Office Action Summary

Application No.	10/605,852	Applicant(s)	WEISS, MARTIN
Examiner	Vinh T. Luong	Art Unit	3682

5. The text of those sections of Title 35, U.S. Code not included in this action can be found in a prior Office action.
6. Claims 15-18, 21, 22, and 25 are rejected under 35 U.S.C. 102(b) as being anticipated by Yamashita (US Patent No. 5,946,978).

Fig. 3

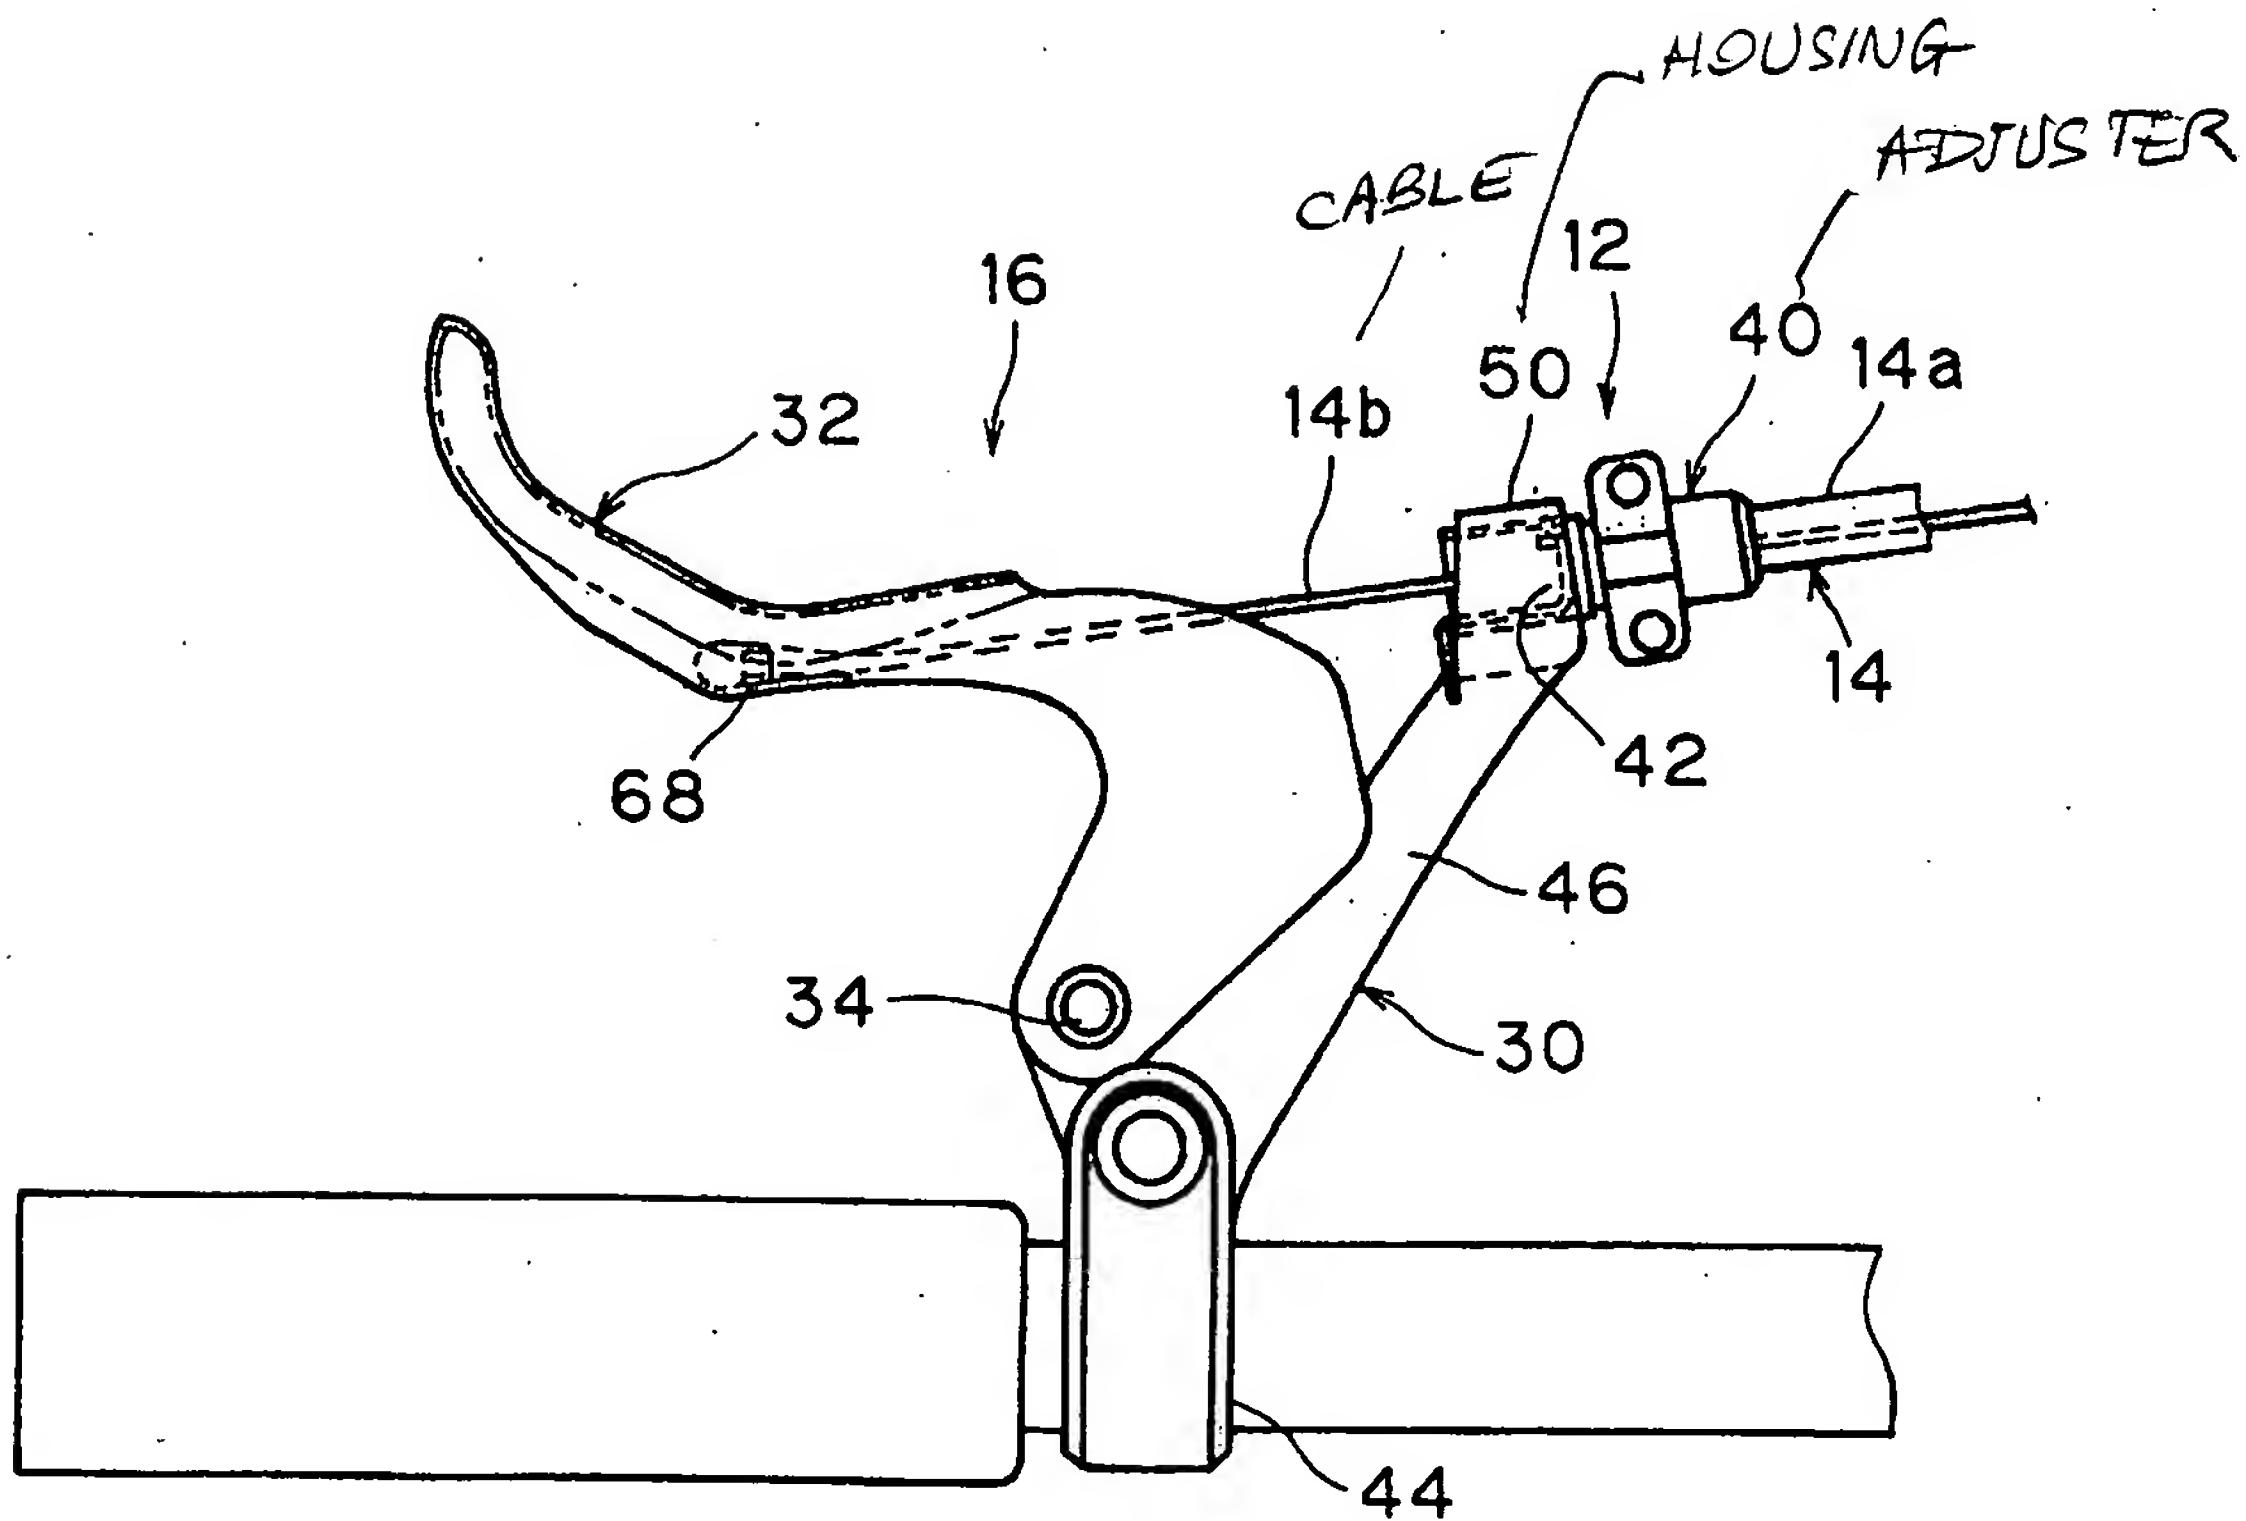
Regarding claim 16, the detent contour 80 has a non-round cross section (FIG. 5) and is configured such that the retention segment 95 has freedom to deflect, the retention segment 95 is configured to extend substantially parallel with the control cable 14b extending through the adjuster 40 (see FIG. 3 in Att.).

Fig. 4

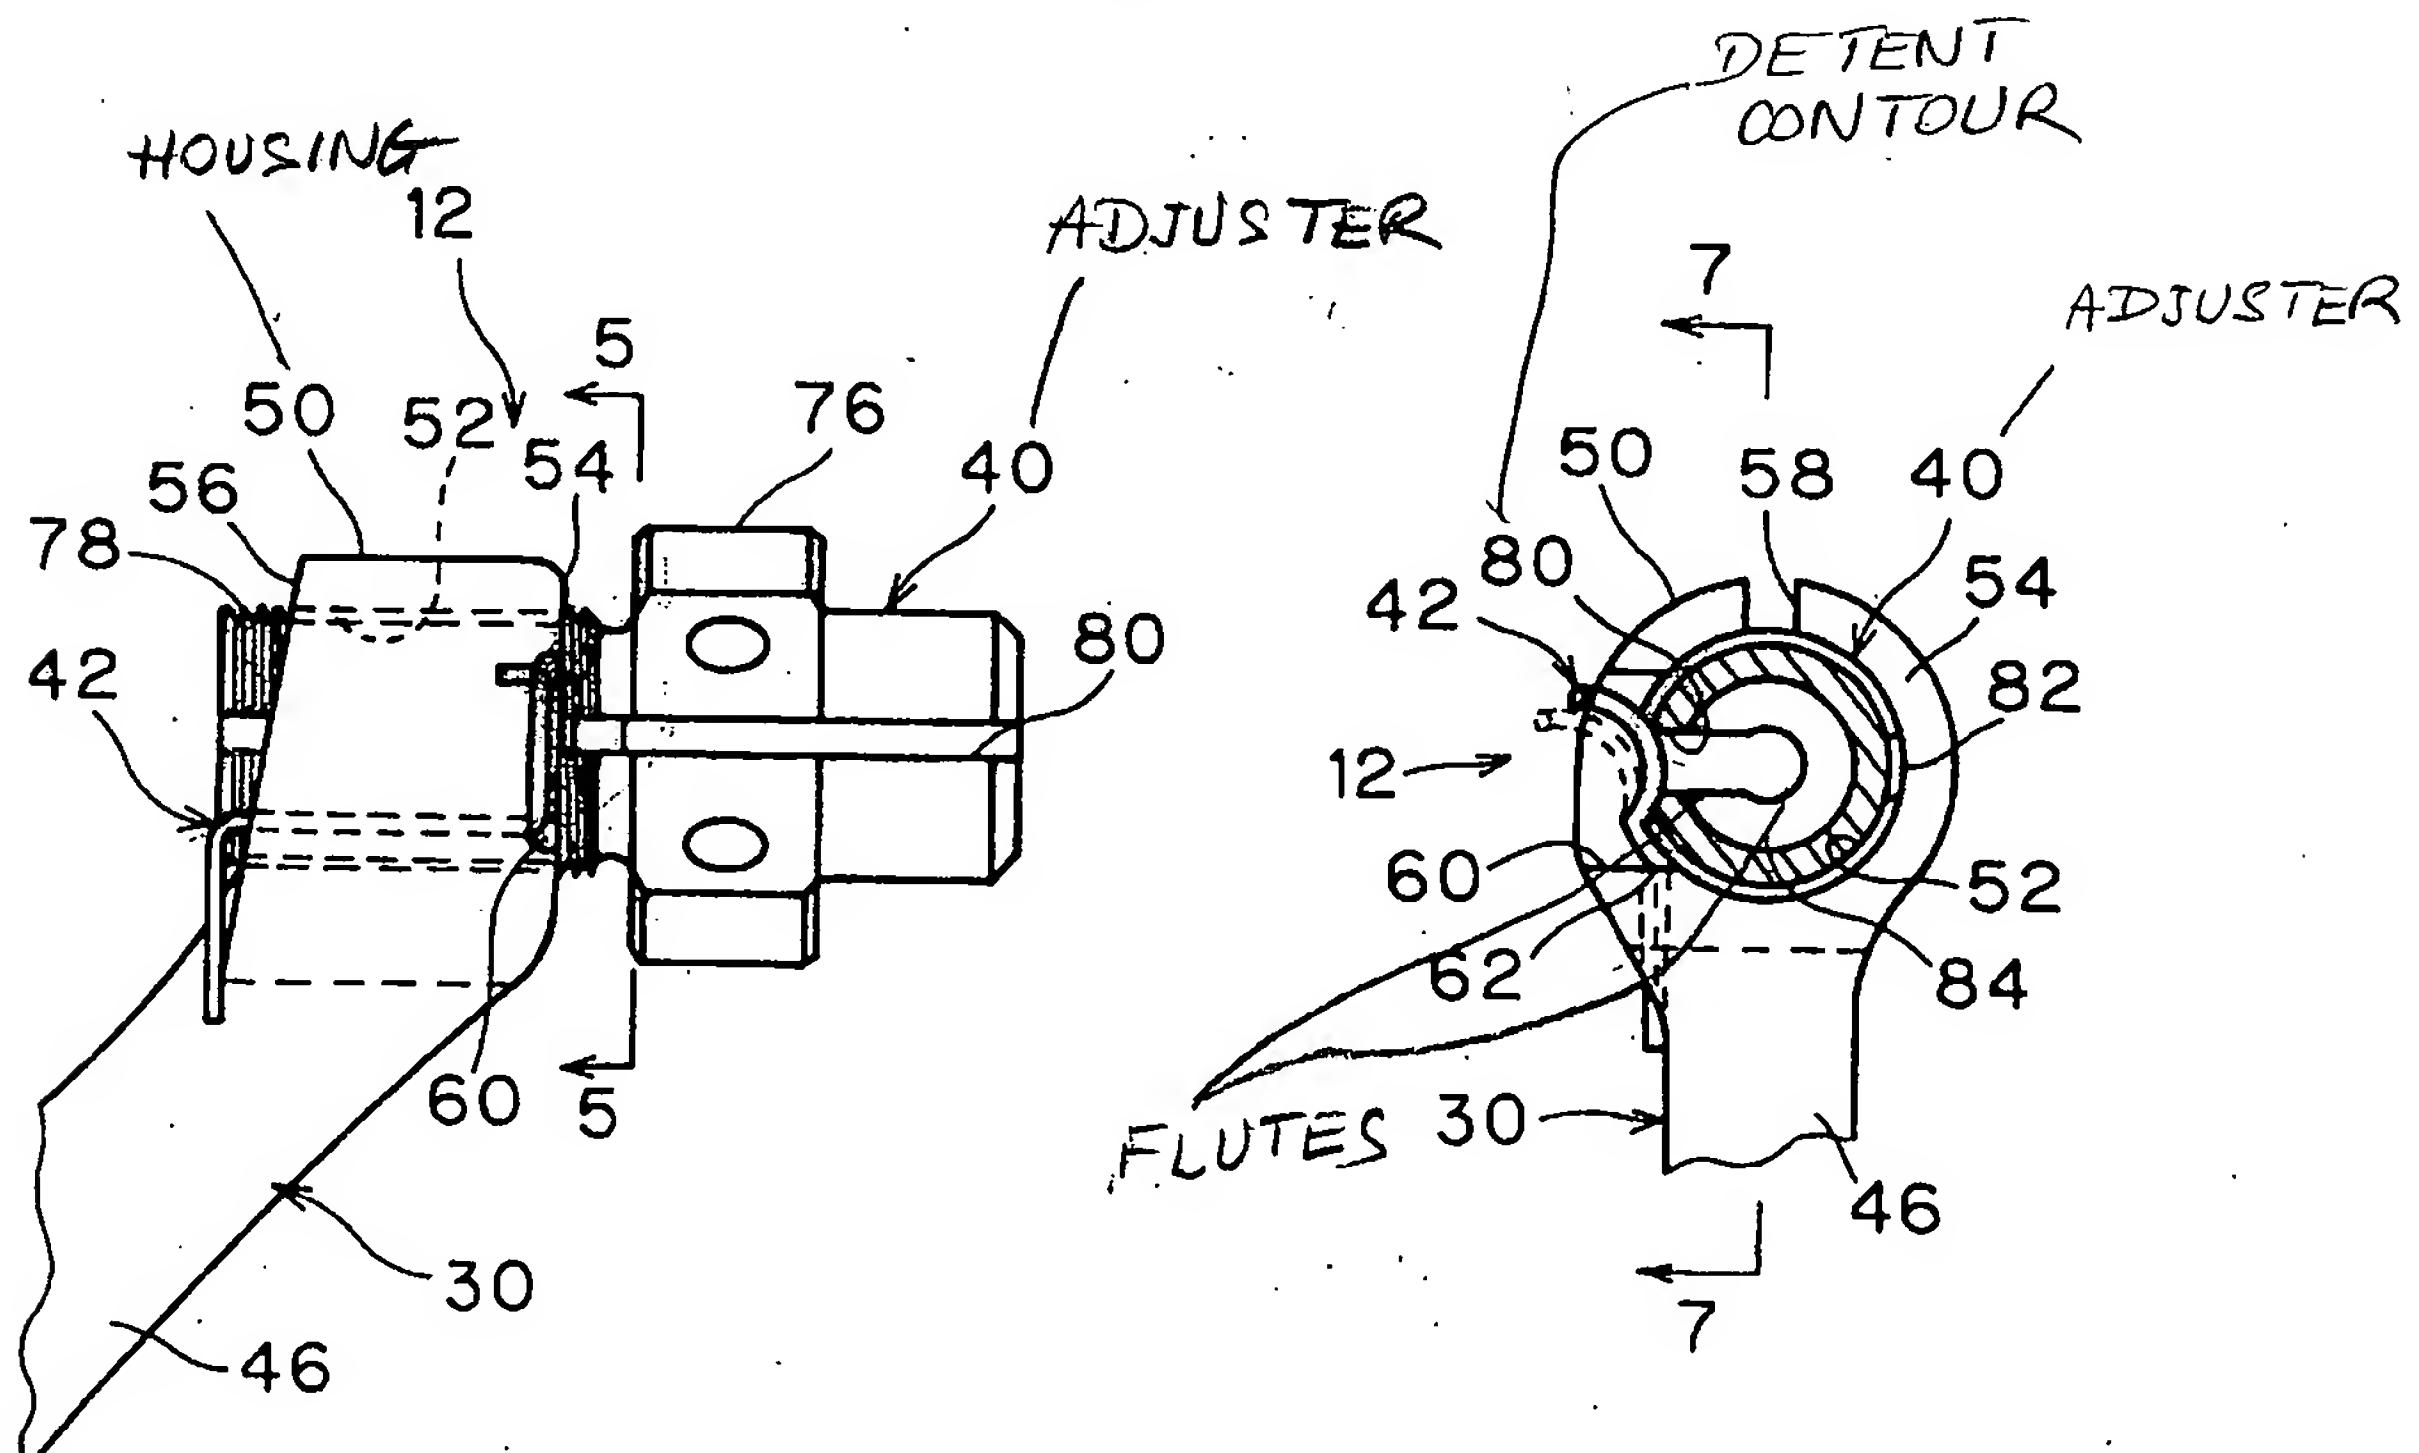
a detent mechanism including a detent contour 80 (see Attachment hereinafter "Att.") extending along a radial interior surface (FIG. 7) of the adjuster 40 and a spring element 42 having at least one retention segment 95 (FIG. 10) and a support segment 93, the retention segment 95 of the spring element 42 engaging the detent contour 80 (*id. col. 6, lines 53-64*), the support segment 93 of the spring element 42 supported by the housing 50 (FIG. 4). *Ibid.*, claims 1-17.

Regarding claim 17, the detent contour 80 includes varying surfaces (FIG. 5) configured to engage the retention segment 95 such that rotation of the adjuster 40 in a first direction inherently requires a higher rotational force than rotation of the adjuster 40 in a second direction.
